Subject : Change Order #2
Proposed 2024 Road Improvement Project
Village of Buchanan

PROJECT: ROADWAY IMPROVEMENTS PROJECT 2024
Village of Buchanan

Subject : Change Order #3
Proposed 2024 Road Improvement Project
Village of Buchanan

Subject : Change Order #4
Proposed 2024 Road Improvement Project
Village of Buchanan

TITLE	EXISTING CONDITIONS & LAYOUT PLAN
PROJECT	PROPOSED TATE AVENUE MUNICIPAL PARKING LOT RECONSTRUCTION
	TAX LOTS 43.15-3-4 & 5
	VILLAGE OF BUCHANAN, WESTCHESTER COUNTY, NEW YORK
SCALE	DATE
1" = 10'	9/19/24
DRAWING NO.	SHEET NO.
C-1	1 OF 3

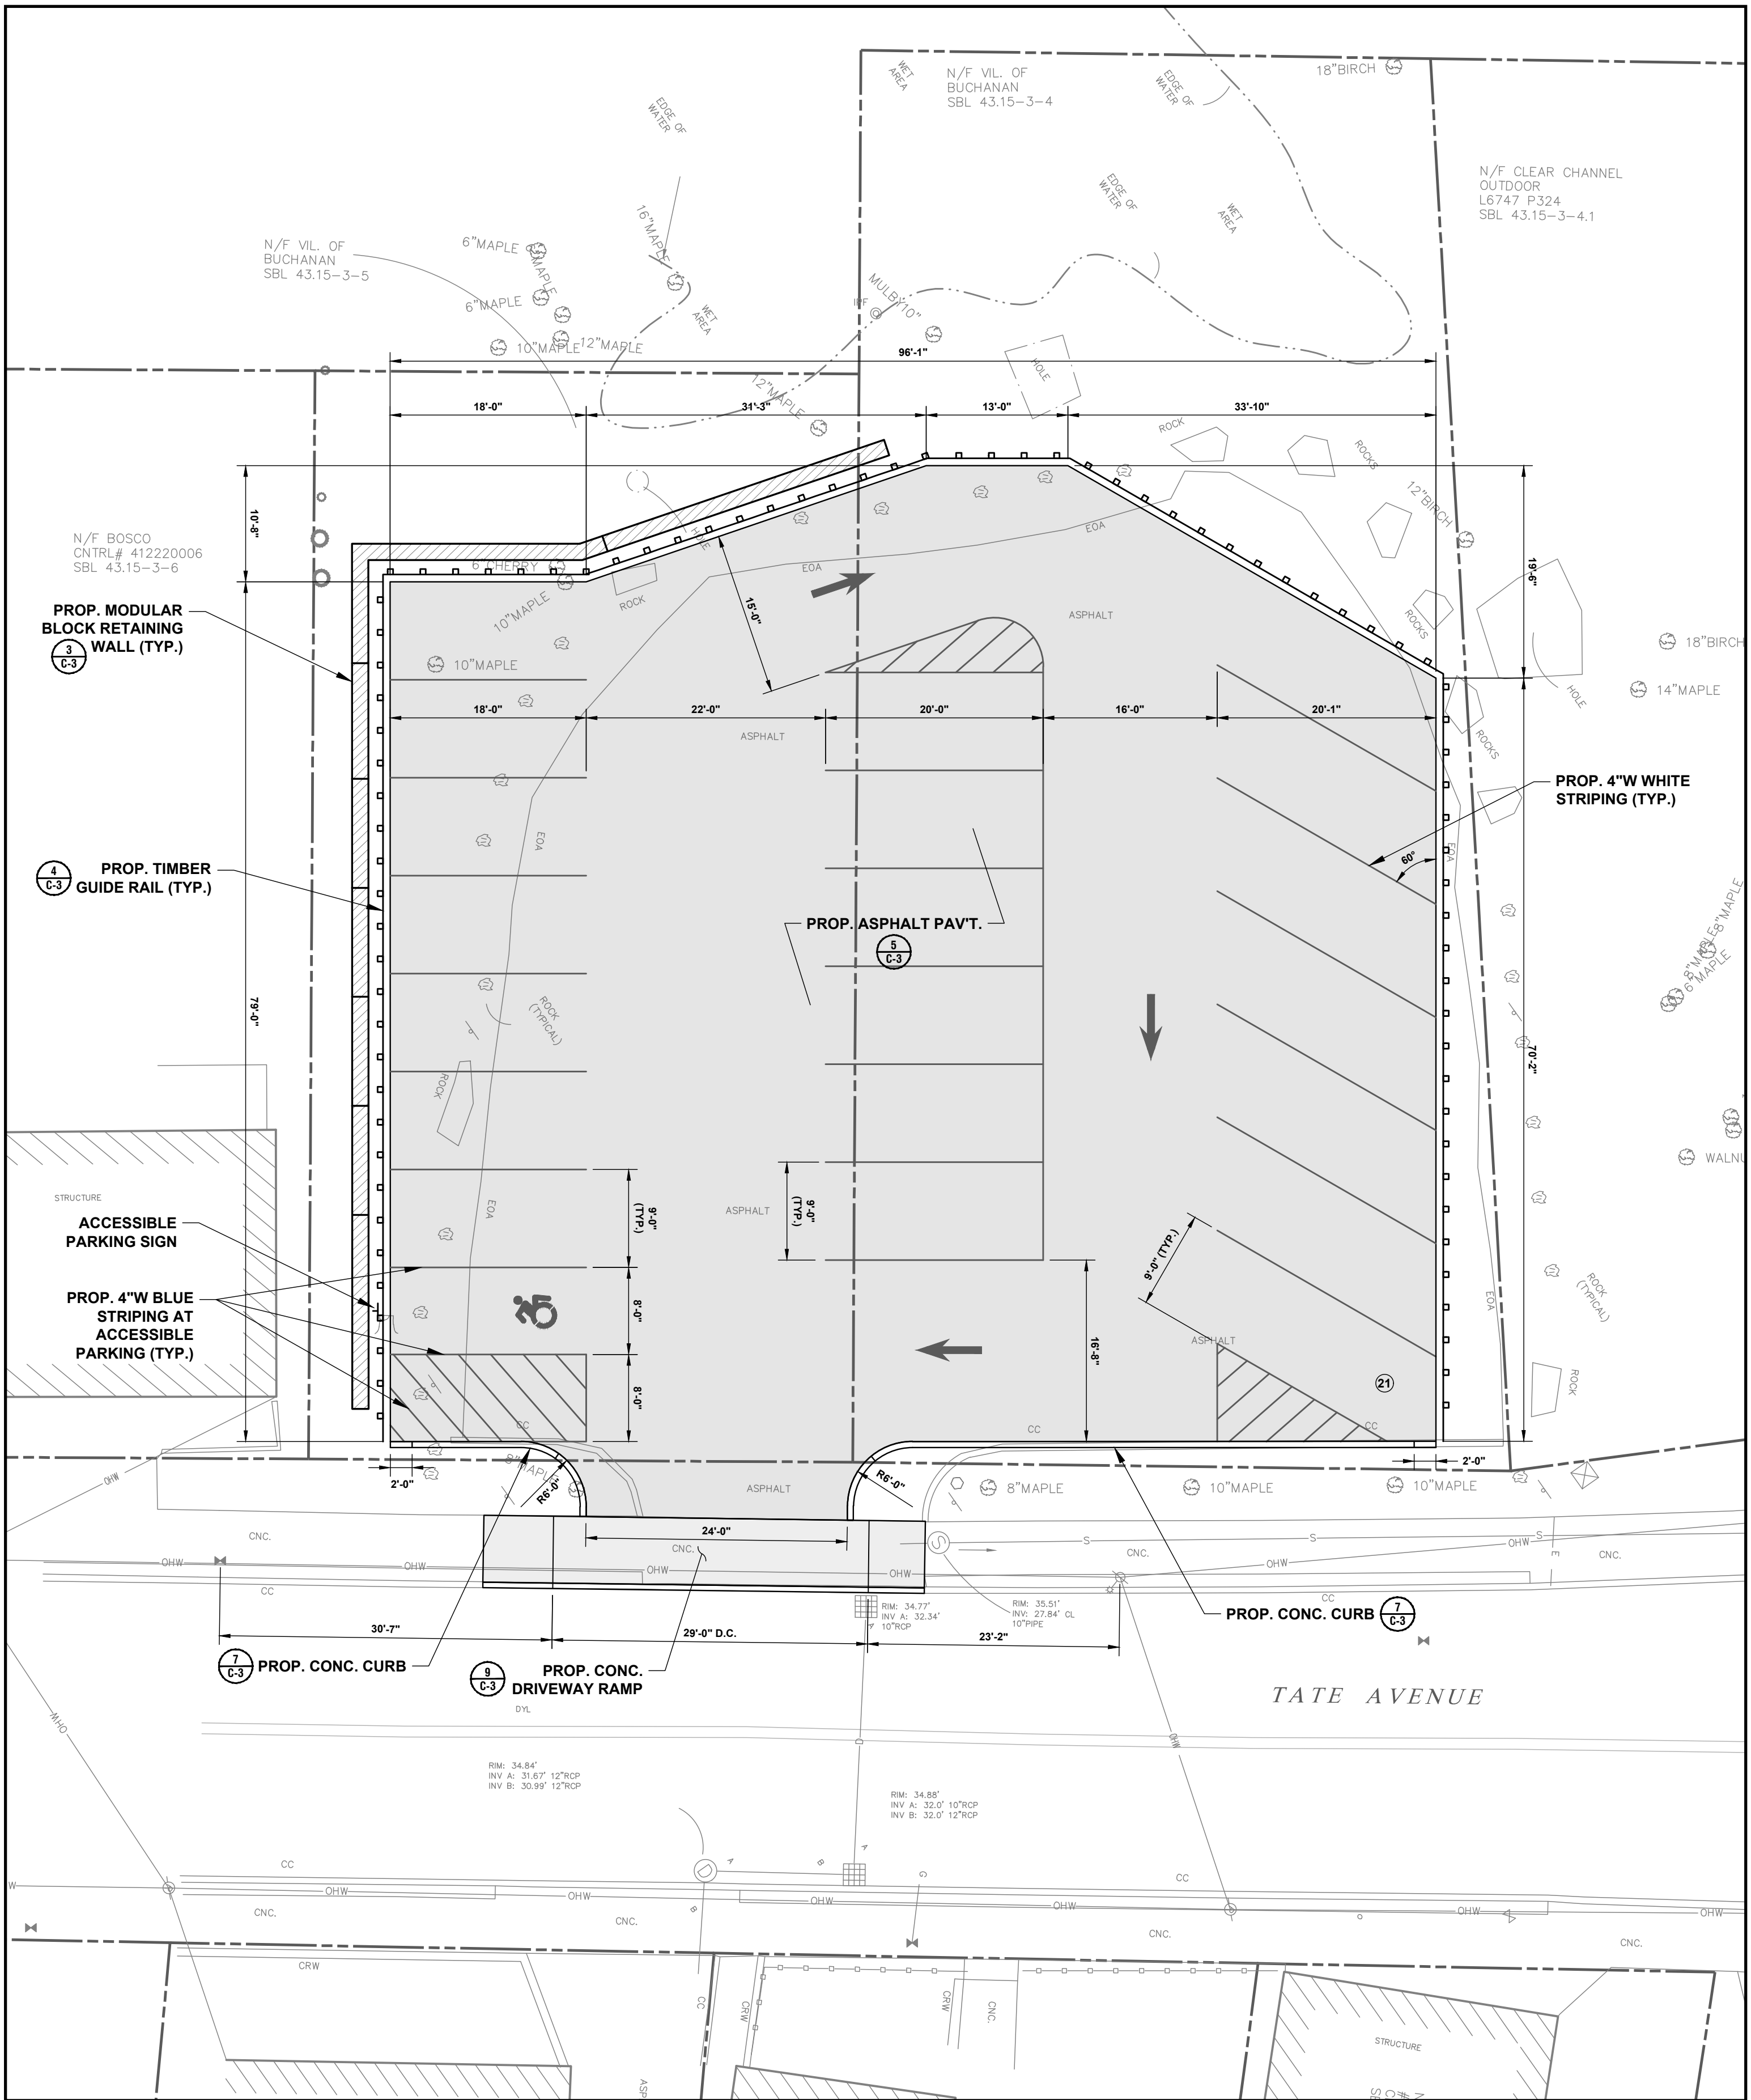
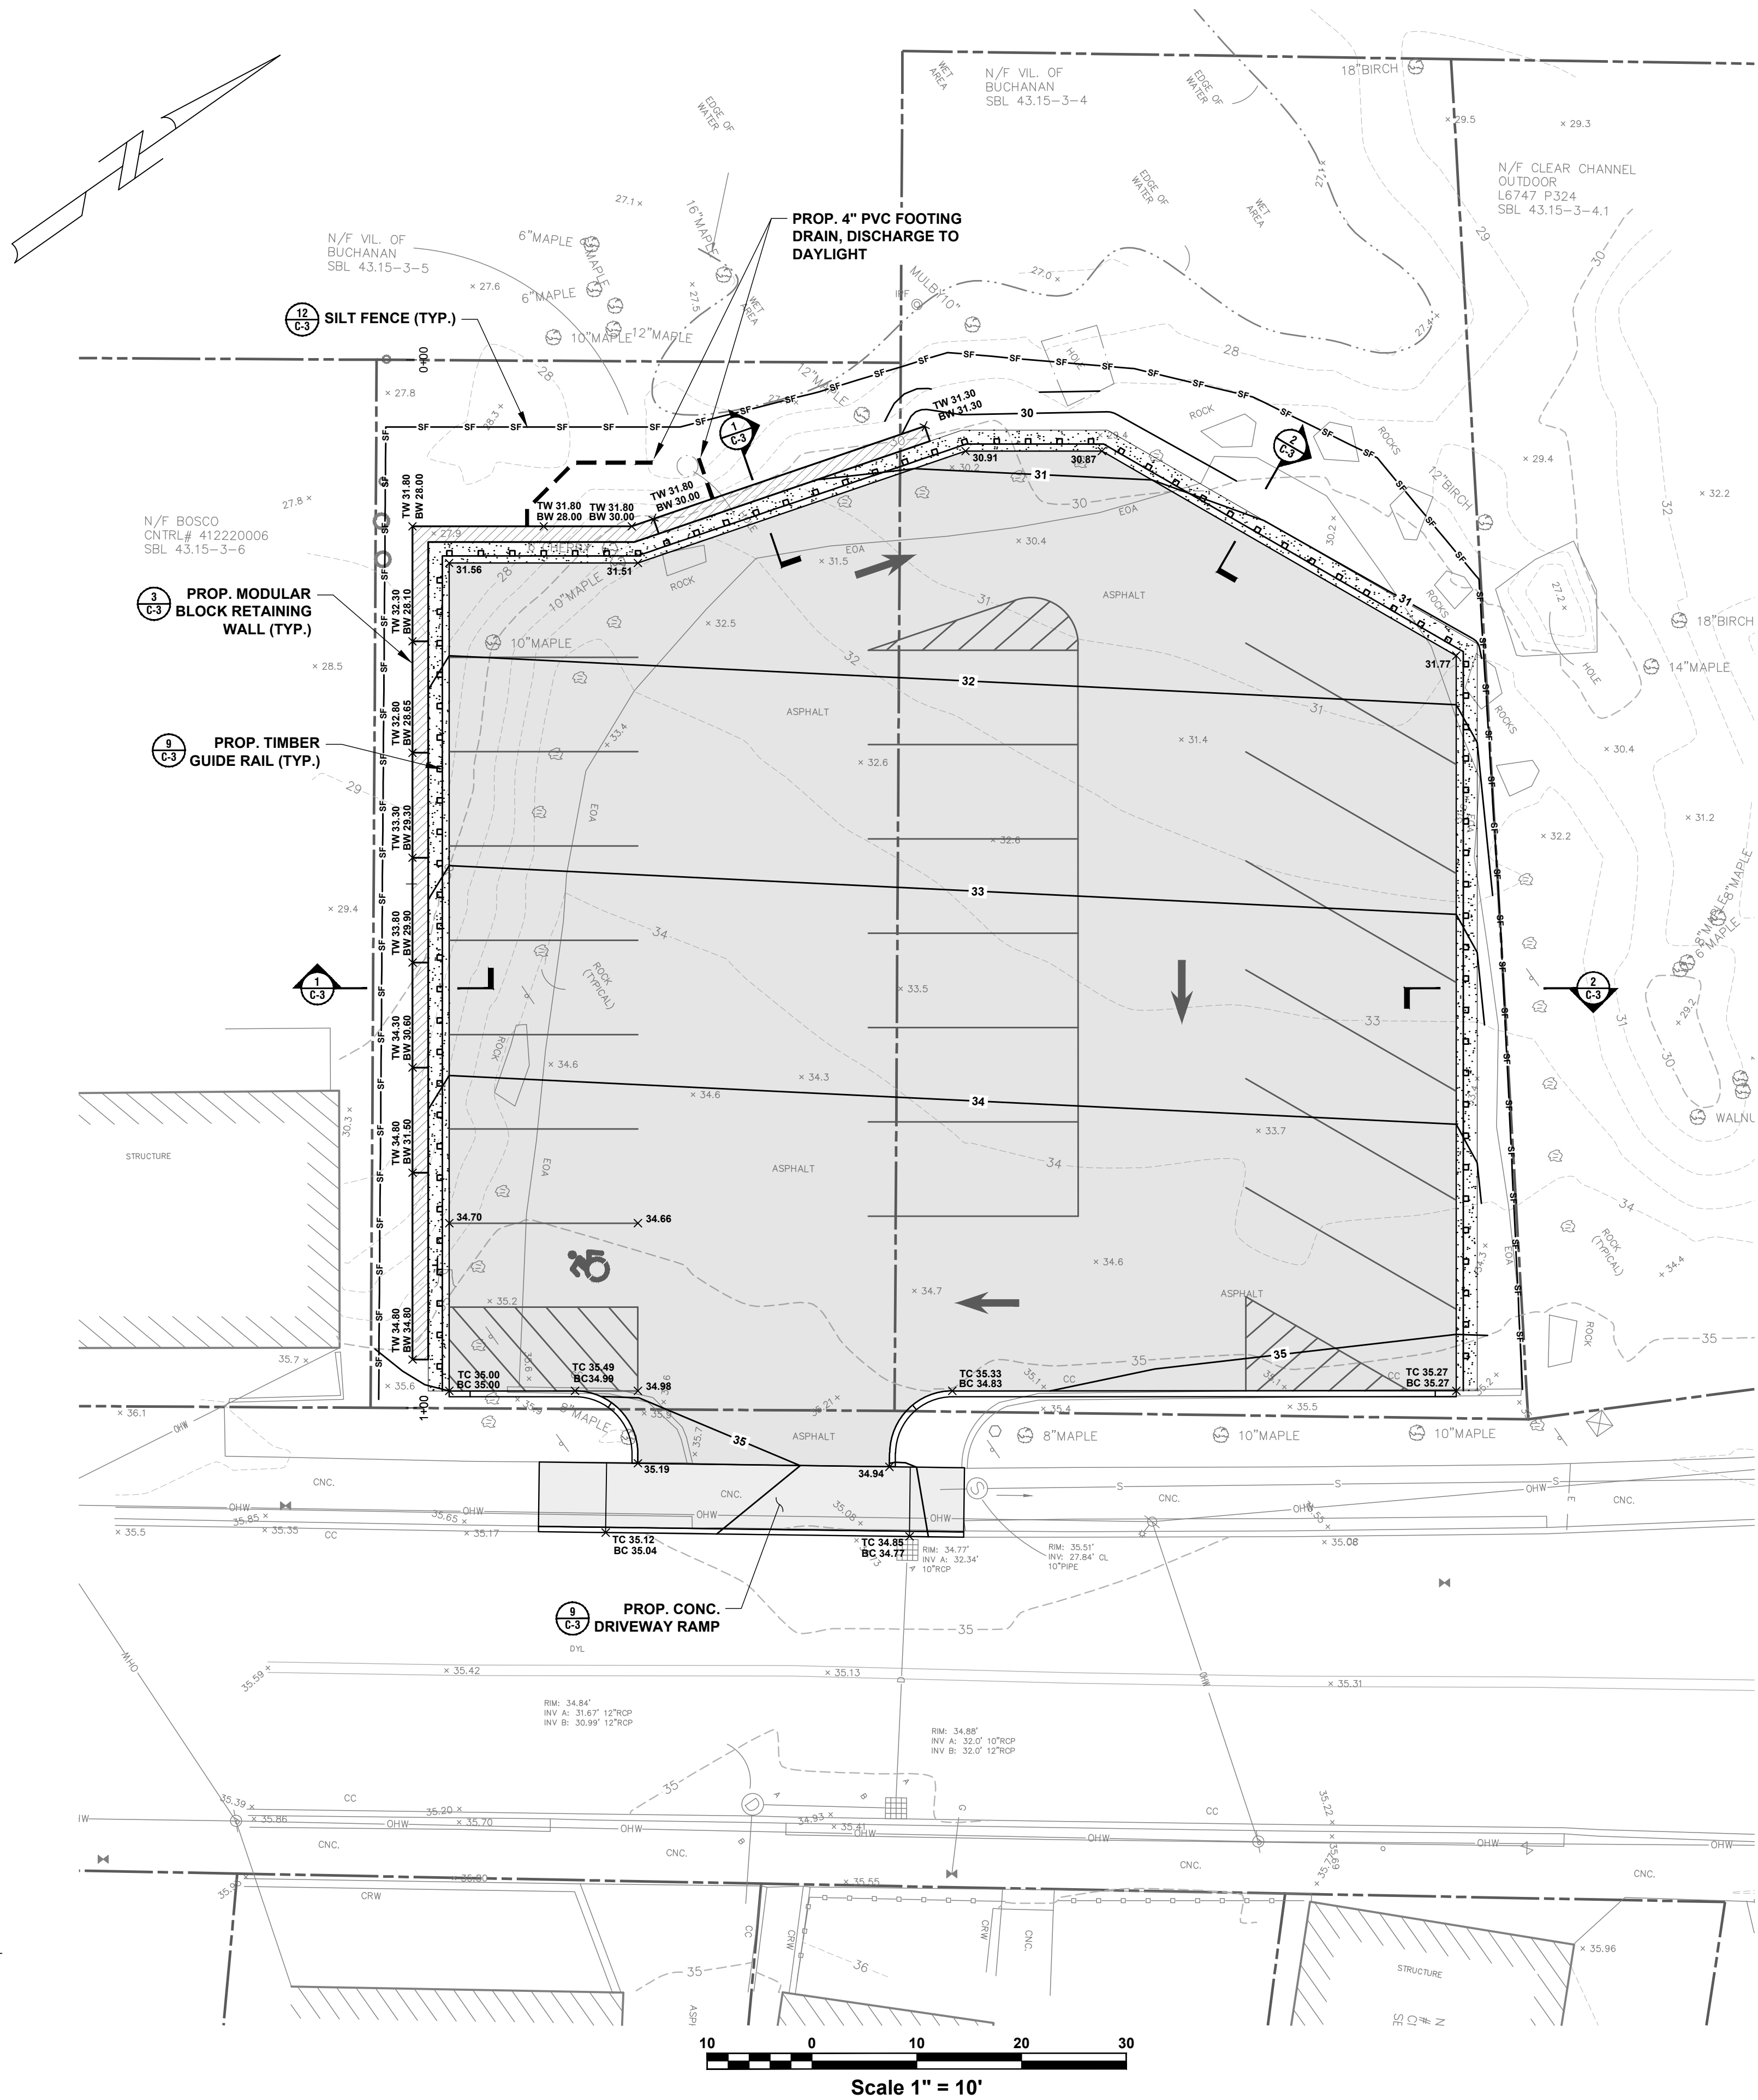
You are directed to make the following changes to the referenced project to include parking lot improvements to the public parking lot located on Tate Avenue in the Village of Buchanan. The work should be paid for as per the prices shown below and the supporting documents from the Contractor.

The work consists of milling and paving the existing public parking lot located on Tate Avenue in the Village of Buchanan. Additional work includes the installation of a modular block retaining wall, the installation of a concrete driveway apron, the installation of timber guide rails as well as line striping and pavement marking symbols. All work is to be completed in accordance with the attached line items sheet, drawings (deemed attached) for Proposed Tate Avenue Public Parking Lot Improvements, Dated June 27, 2024, Drawing C-3, by James J. Hahn Engineering, PC, and Village of Buchanan Roadway Improvement Project 2024 contract documents.
